Sub.: WII report on review of proposed mitigation measures on NH 37 at
Kaziranga National Park, Assam - reg.

Review Report

Review of Proposed Mitigation Measures National Highway 37 Passing through Kaziranga National Park, Assam

Figure 5: Proposed flyover from Seconi T.E. to Kuthari with 5 road stretches connecting about 35 villages to the flyover.

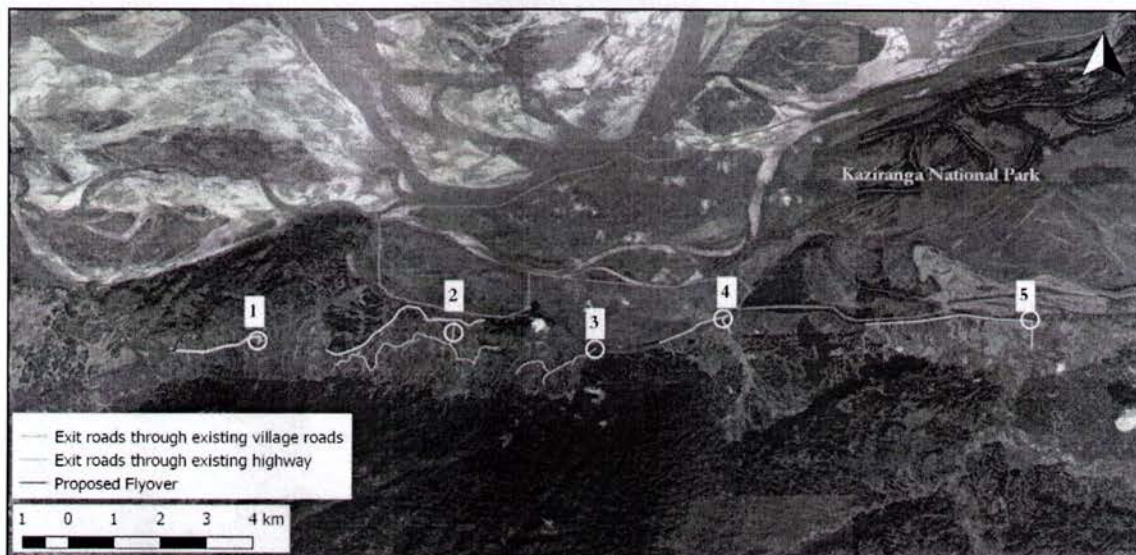
For this stretch measuring 20 km from Seconi T.E. No.4 ($26^{\circ}34'9.96''\text{N}$, $93^{\circ}1'14.47''\text{E}$) to Kuthari ($26^{\circ}34'27.84''\text{N}$, $93^{\circ}12'49.26''\text{E}$), it is suggested to provide access to villages to the flyover through **3 stretches** of the existing road and connecting these stretches to the flyover (Figure 5). The remaining stretches of existing roads should be decommissioned i.e., rendered non-functional. Near the Deosur Hill, where the proposed alignment is diverted behind the hill, it is recommended to develop existing village roads as access roads for connecting these villages and to the flyover. The details are given below in Table 1.

Figure 13: Exit road no. 7 linking settlements to proposed flyover (at corridor II) through existing highway.

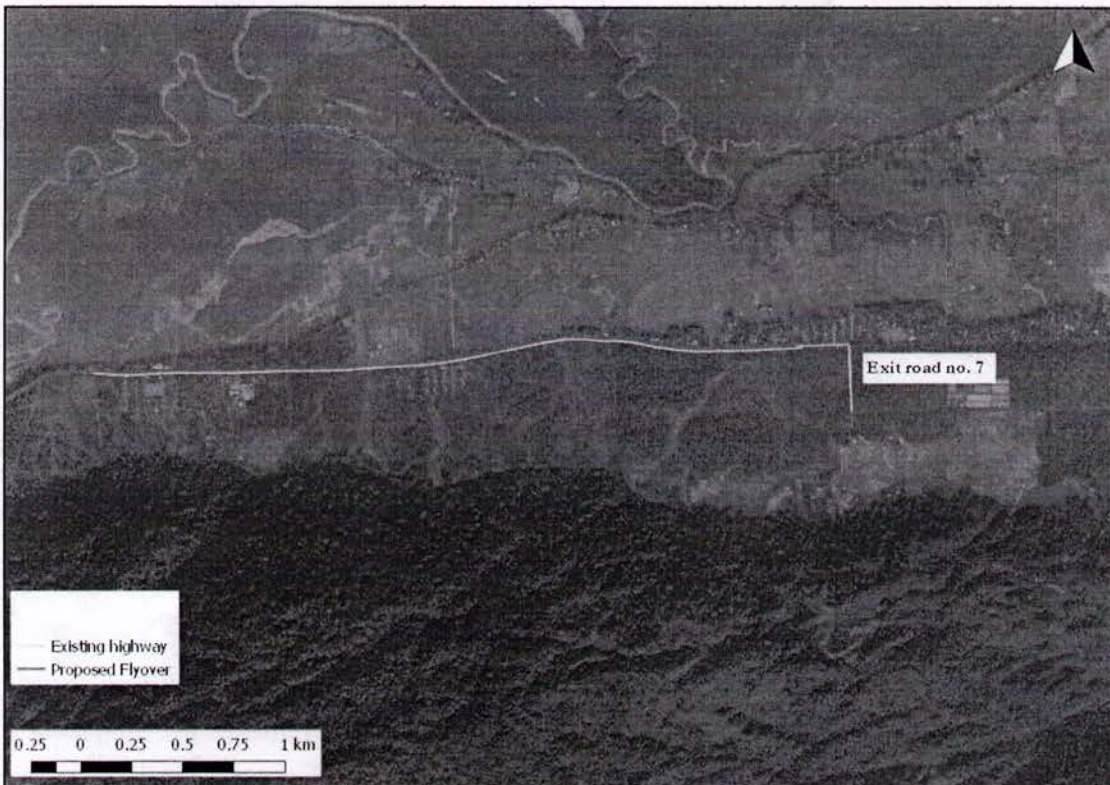
The major part of this proposed corridor consists of villages and plantations, and 3 major animal corridors. It is suggested to allow two stretches of roads to function as access roads to be connected to the flyover (Figure 11). The remaining stretches of existing roads should be decommissioned i.e., rendered non-functional. The details are given below in Table 2.

Figure 14: Proposed flyover (at corridor III).

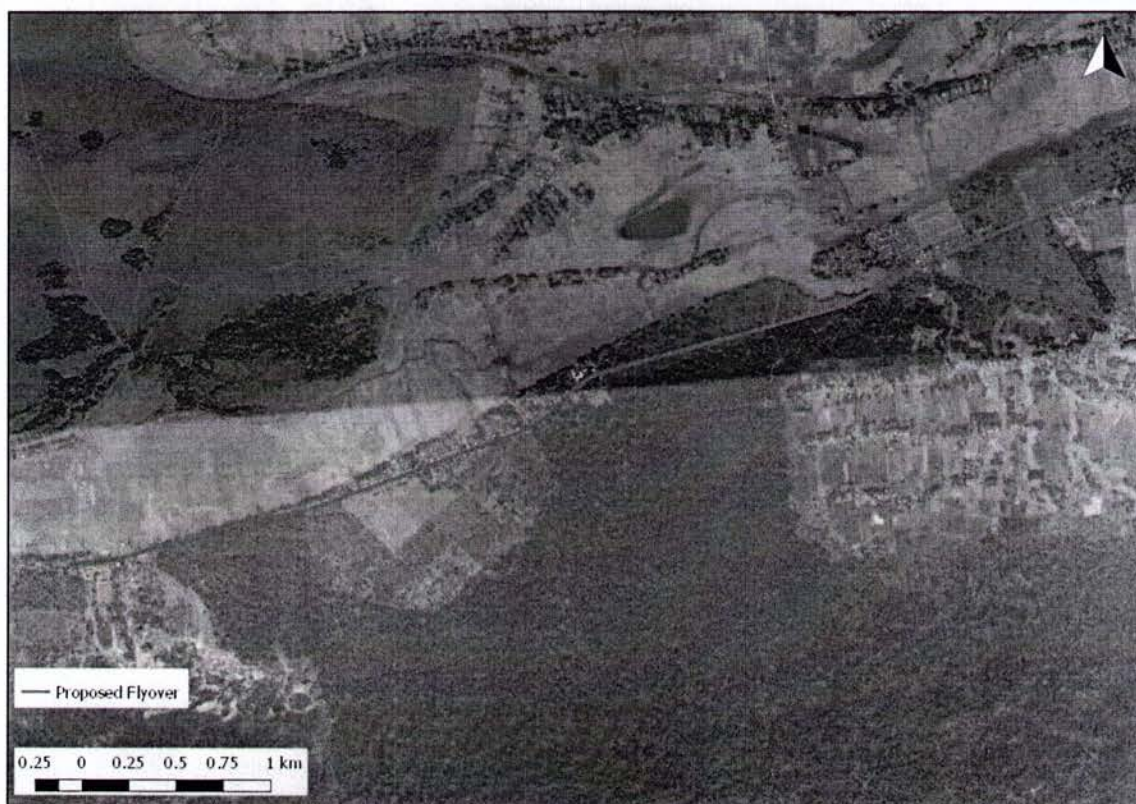
The 5 km stretch of flyover is suitable for the purpose of providing safe passage to animals (Figure 14). However, removal of the present road after construction of the flyover should be ensured.
